# Transportation Staff Meeting

Subject: TCC Comments on Environmental Assessment for Consolidated TIP Projects  
I-3311C, I-5405, and I-4750(HOT)

SUBJECT: Response to Request for Comments, TIP Project I-5405

# I-77 Improvements and Non-Motorized Transportation Facilities

## **Town of Mooresville Crossings**

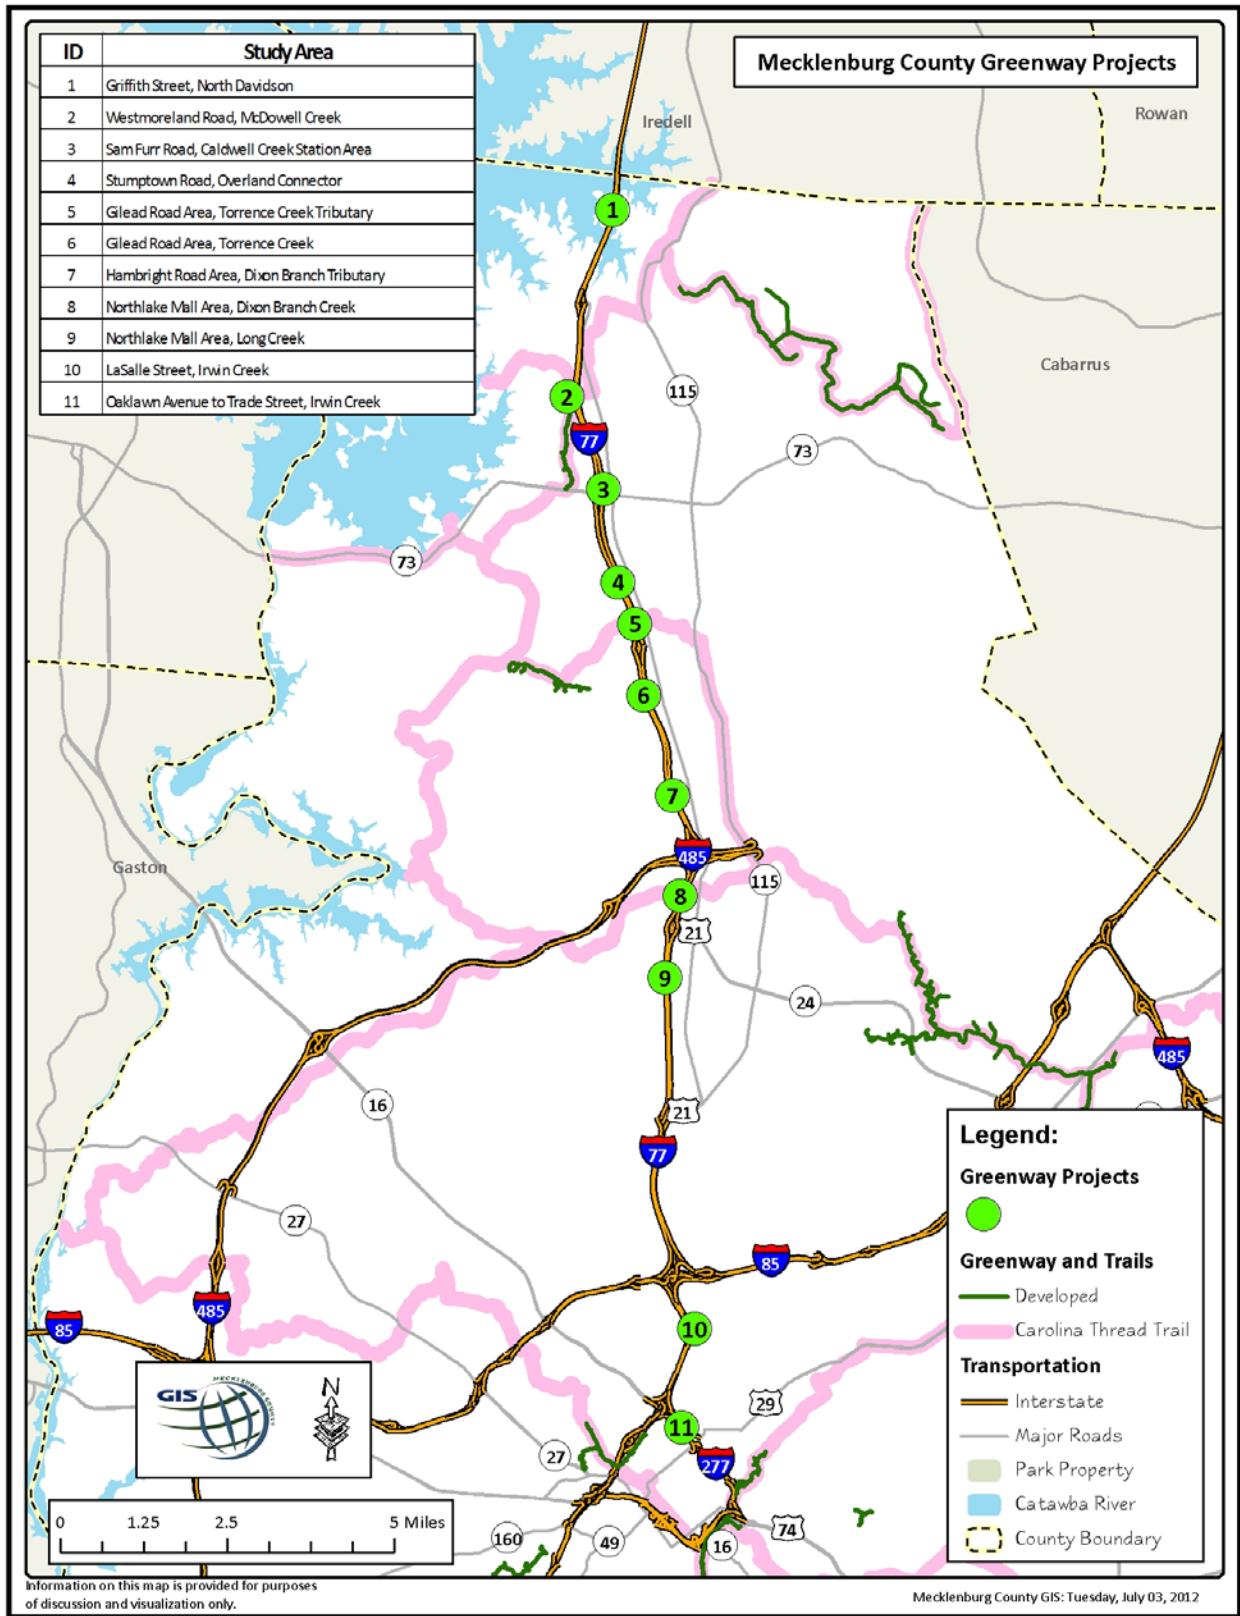
- The conversion of an existing culvert under I-77 between NC 150 and Troutman is recommended in the Mooresville Bicycle Plan. This has not been thoroughly investigated to determine if a bicycle and pedestrian connection is feasible in this location.

- The Town of Mooresville has a proposed interchange overpass over I-77 linking Midnight Lane and Oates Road just north of NC 150 in the Mooresville CTP. An alignment study was completed and the cross section for this overpass would include bicycle and pedestrian accommodations.

- The conversion of the I-77/NC 150 interchange to a diverging diamond interchange (DDI) is in the state TIP (SPOT ID 1182). Bicycle and pedestrian enhancements should be incorporated into the design of the DDI.

- The Town of Mooresville and NCDOT are currently working on a feasibility study for constructing an overpass linking Fairview Road and Alcove Road and possible interchange modifications to US 21/Williamson Road (Exit 33). Bicycle and pedestrian accommodations should be part of this overpass.

- The I-77/Langtree Road interchange was open to traffic in 2009. Currently there are no bicycle or pedestrian treatments along Langtree Road in the vicinity of the I-77 interchange. The Comprehensive Bicycle Plan identified Langtree Road corridor as “future bicycle facilities by policy” and recommended paved shoulders and wide outside lanes.

### **2. Westmoreland Road/McDowell Creek**

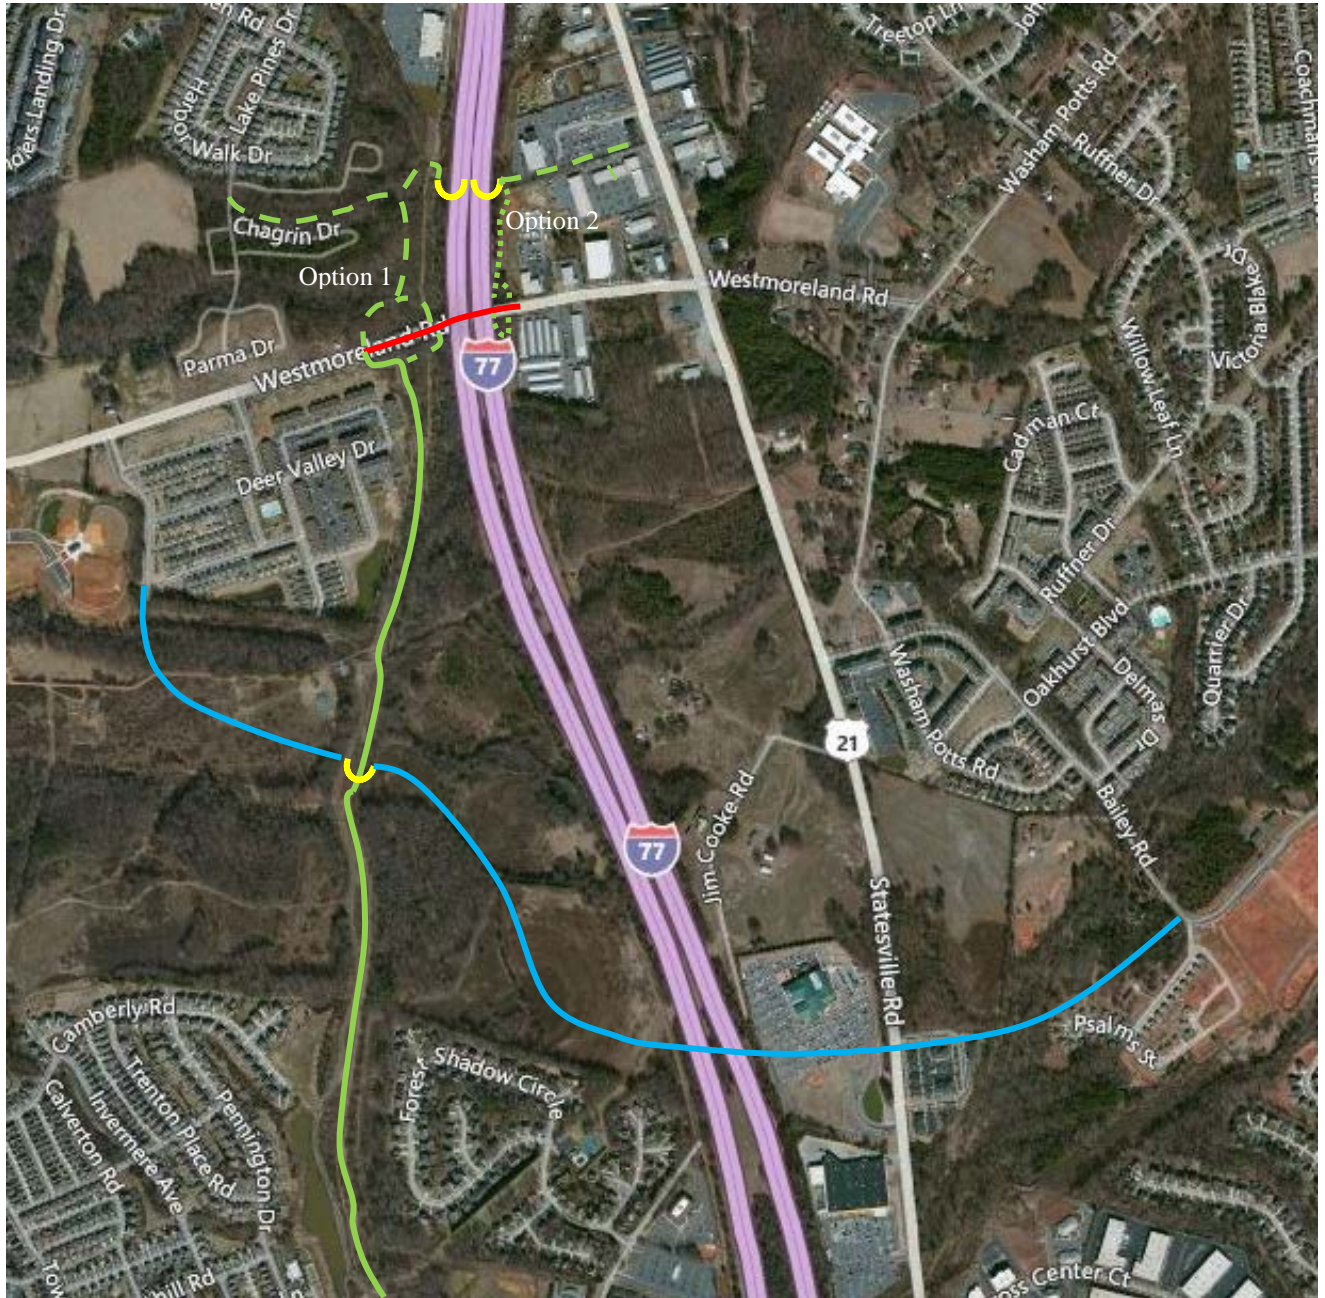
- Provide grade separated passage under I-77 to the east side, exiting near the creek.
- Create grade-separated crossing at both ends of the bridge to provide connectivity to the sidewalks on Westmoreland Road. .
- The greenway trail continues north along the west side of the I-77 ROW.

- A future bridge that connects Bailey Road and North Cross Drive, but does not directly access I-77, will include pedestrian/bicycle facilities with a planned 10' multi-use trail on one side and a 5' sidewalk on the other side.

All three connections are identified as important pedestrian connections in the adopted Cornelius Pedestrian Plan. While the bicycle-pedestrian accommodations on Westmoreland Road are an acceptable alternative, separated grade crossings are preferred. Option 1 and 2 will require grade separated crossings at each end of the bridge.

Continue to plan for the future bridge as an important connector for both bicycle and pedestrian systems.

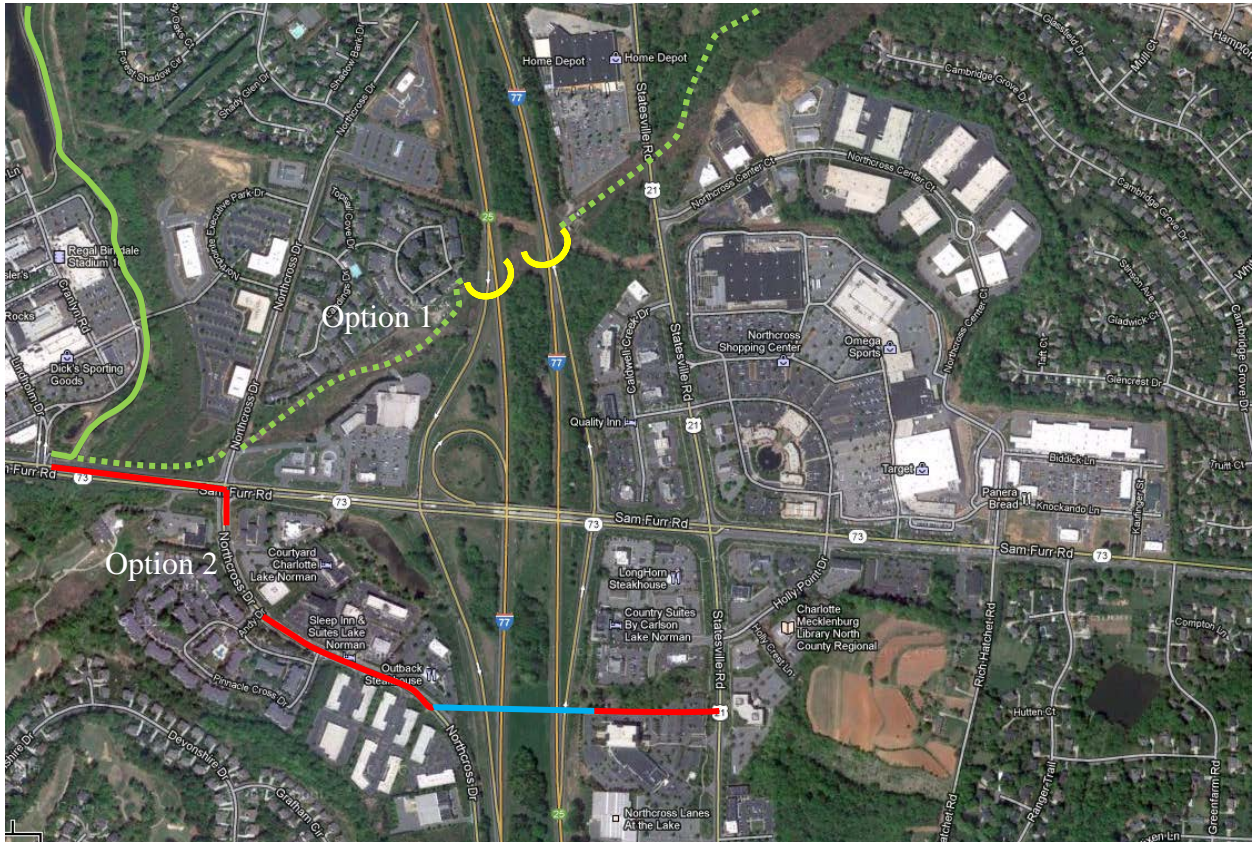
- New bridges must include bicycle-pedestrian accommodations.
- Proposed roundabouts must not conflict with bicycle-pedestrian accommodations.
- Additional bicycle-pedestrian accommodations must be added to Northcross Drive.

Option 1 is preferred; however bicycle-pedestrian accommodations on proposed bridges/ and connecting roads is an acceptable alternative.

### 3. Sam Furr Road/Caldwell Station Creek Area

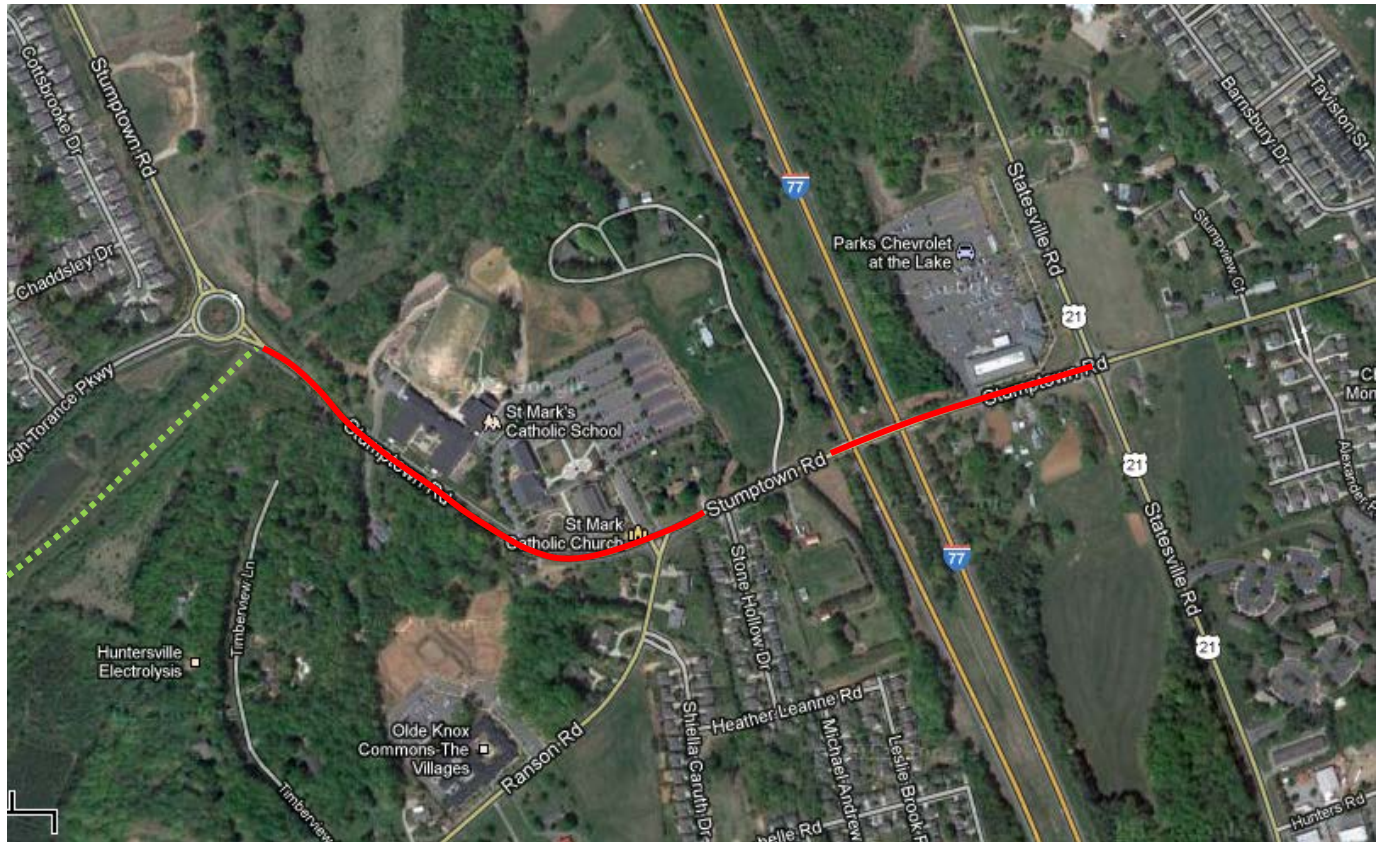
- Provide bicycle-pedestrian accommodations on the new bridge. Bike lanes to be a minimum of 6 feet in width excluding shy distance to accommodate NC Bike Route #6.

- Restriping existing bridge to provide bicycle-pedestrian accommodations if possible.

Provide bicycle-pedestrian accommodations on both sides of Stumptown Road as it cross I-77

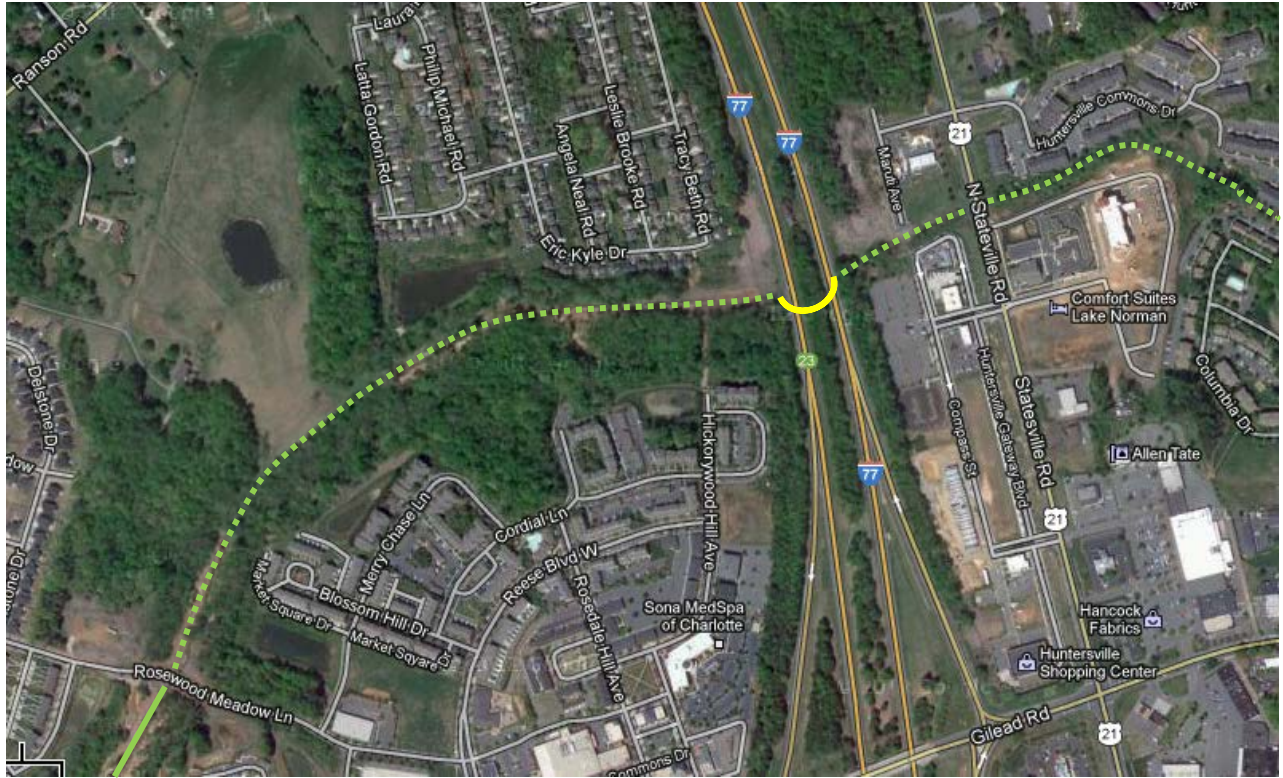
- Future greenway trail must cross I-77 and return to the creek alignment on both sides of I-77.
- Torrence Creek Tributary #2 is identified as a greenway corridor on the Huntersville Greenway Plan, the Mecklenburg County Greenway Master Plan and the Carolina Thread Trail.

Construct a grade-separated crossing under I-77 north of the existing culvert.

## 5. Gilead Road Area/Torrence Creek Tributary #2

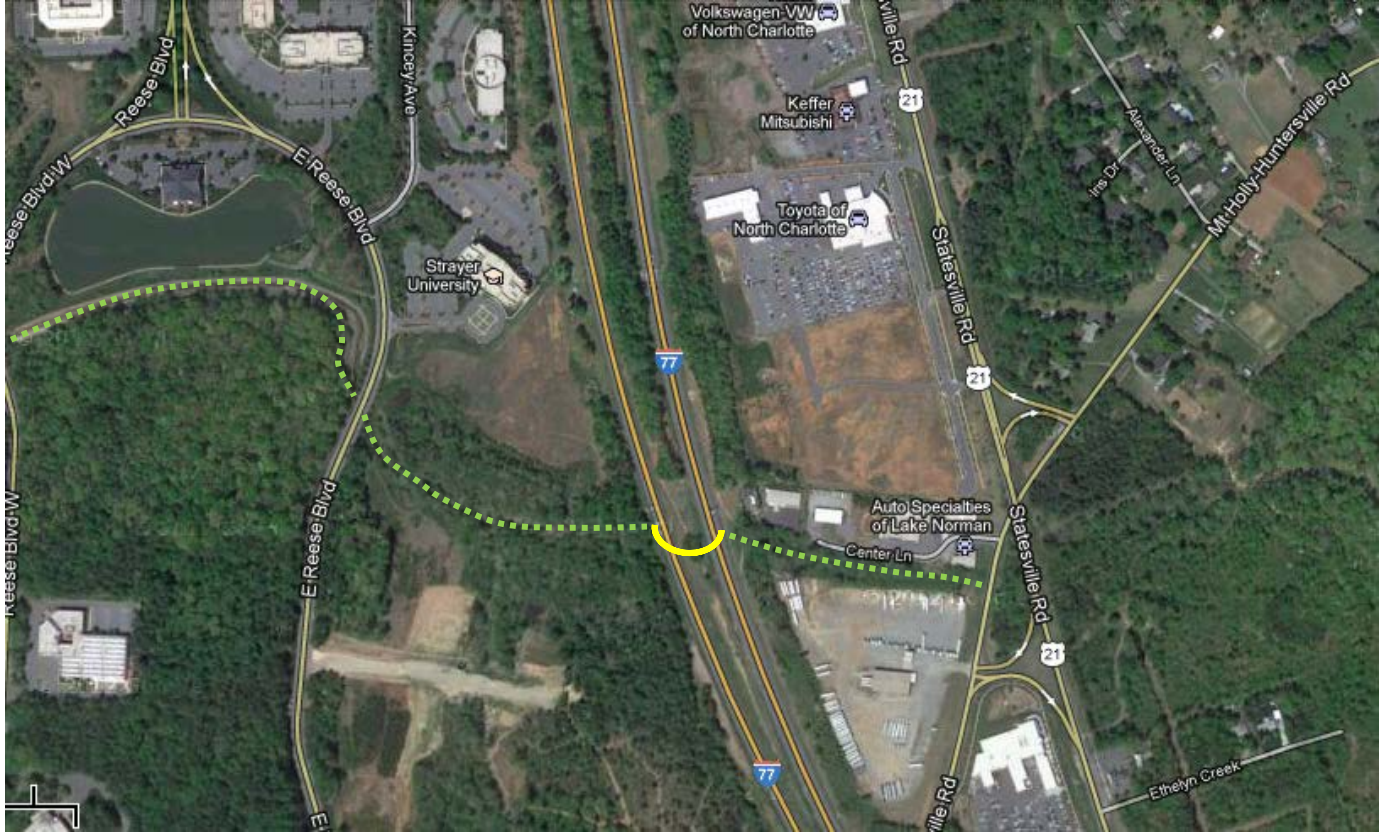
- Provide a shallow grade-separated crossing under I-77 following Torrence Creek or parallel to the creek but in a separate structure.

Construct a grade-separated crossing under I-77 north of the existing culvert.

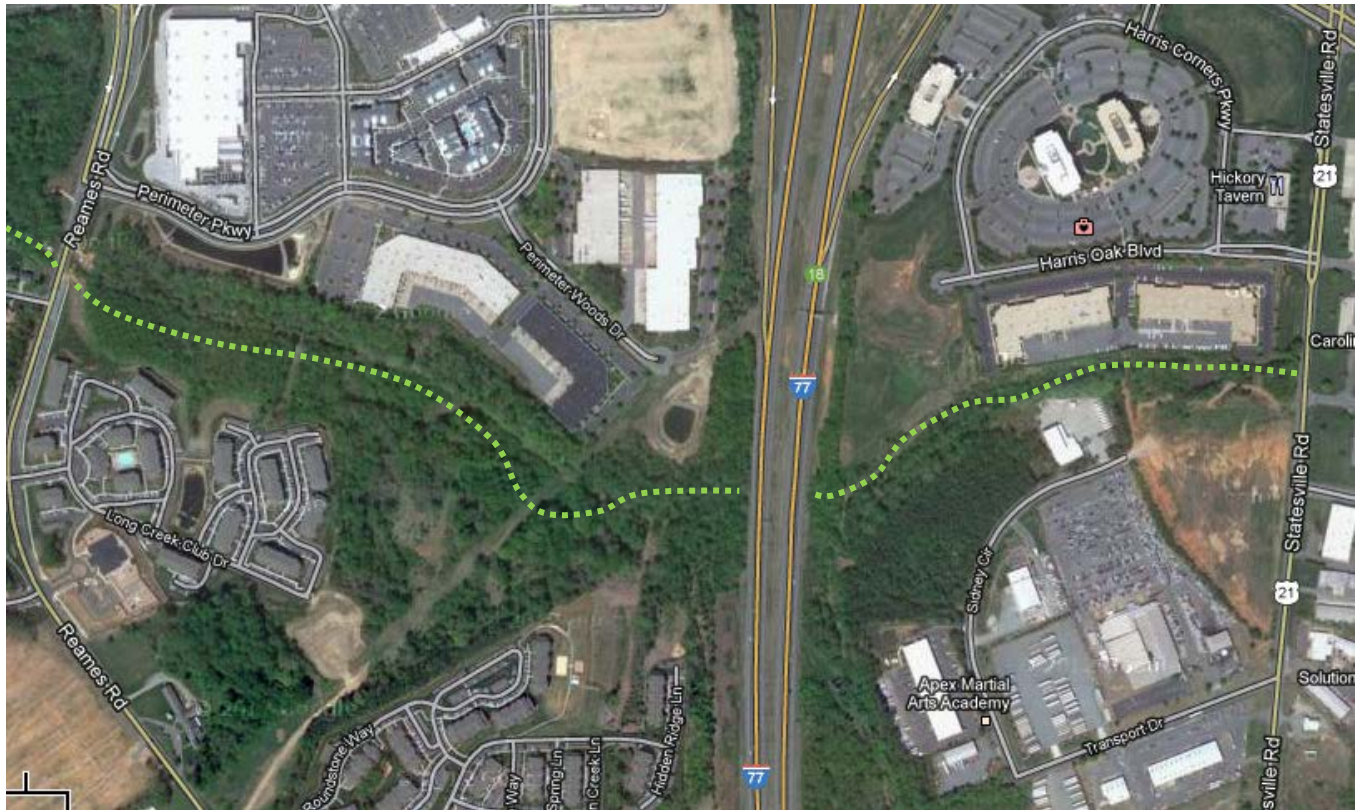
- Long Creek passes under as I-77 through two large and significant box culverts.

The existing culverts are expected to be adequate for passage of a greenway trail. The constraint of grading and flood modeling will need to be addressed.
